MEMORANDUM

From:	Finlay Rothery Green Infrastructure Support Officer		
Service	WBC Infrastructure	Green	App No: 252782
Address:	Former Prince Bros / Grove Service Station, Old Bath Road, Charvil, Twyford, RG10 9QJ.		
Proposal:	Full application for the proposed change of use from service station to a fuel oil storage and distribution facility including demolition of 2 no. existing buildings and a garage and the recladding of the existing building, installation of 8 no. fuel oil storage tanks and construction of retaining structures, plus refurbishment of hardstanding, car parking and other associated works.		
Type of Development:	Minor General industrial/storage/warehouse (1-999 sqm)		
Site Visit Made:	Yes (25/11/25)

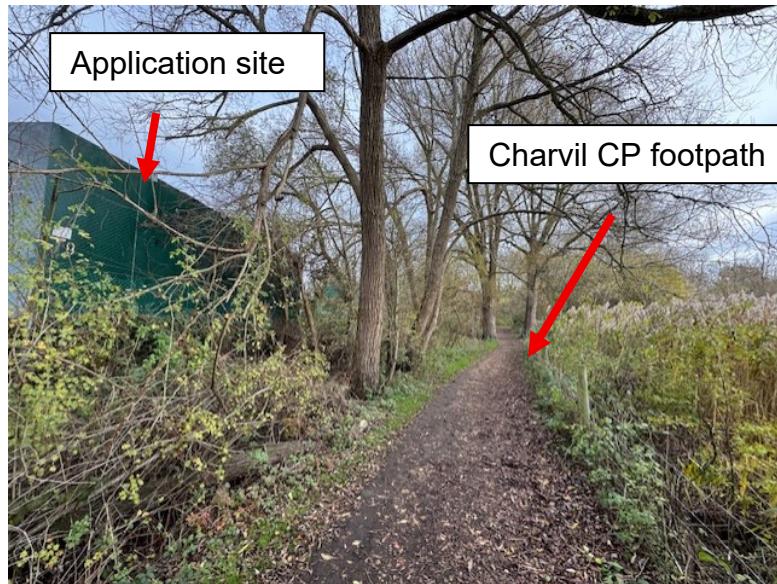
As detailed in the Ecological report submitted by the applicant, within the impact risk zone of the site is a SSSI, and a Biodiversity Opportunity area, and habitats which are of both county and national importance. Further, the site is surrounded by well-connected waterways which flood regularly (see photo below – application site is centre of the image), meaning any contamination events would not remain localised and could adversely affect greenspaces further afield.

I disagree that the closest, most sensitive receptors (i.e. the lakeside path to the south of the application site) will not experience any significant visual impacts. Photo below (taken 25/11/25) shows the proximity of the application site to the footpath and lake (vegetation on right of photo is reedbed within lake boundary).

The proposed paladin fencing and gabion baskets (which would appear to be sited outside of the site boundary, thus encroaching on the country park), provide a harsh and unnatural visual barrier. The proposed hedgerow planting inside the fence will do little to mitigate the visual intrusion of the large vehicles using the 15 parking bays along the entire southern fence line. This would have a significantly urbanising effect, detracting from the natural surroundings of the green space and lowering its quality. As such, I do not believe this application satisfies Wokingham Borough Council Local Plan Policy TB21.
